SAFETY ALERT

Incident Involving Powered Rope Access Equipment

Figure 2. Superseded rope cover.

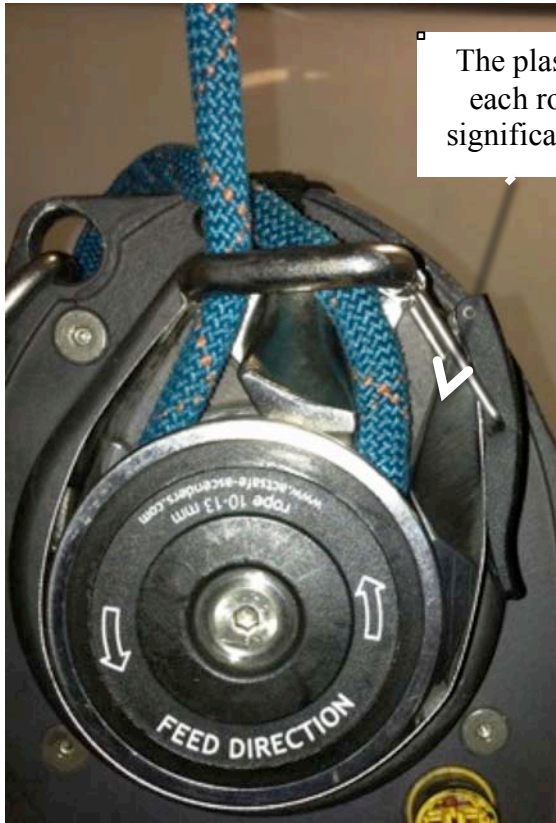
Superseded rope cover

To Be Removed and Replaced

The equipment manufacturer (ActSafe) distributed a safety notice to all distributors in 2009 notifying them of a number of safety measures that are required of end users. Included in this safety alert was the need to change out the rope cover to a new design. The replacement rope cover was offered to end users free of charge.

1. Notify end users of the incident details through this safety alert.
2. End users to inspect their equipment to identify if their unit has a superseded rope cover. This applies to ACC 1 models manufactured during, or prior to 2009.
3. If a unit is found to have a superseded rope cover, it must be immediately removed from service and the user contact the Manufacturer.
4. All devices to be sent to the authorised service agent at least annually for inspection.
5. Users to only insert the emergency descent pin when necessary for emergency descent and to remove the pin at all other times. The emergency descent manually disengages the brake, and will function even when the electrical system is isolated.
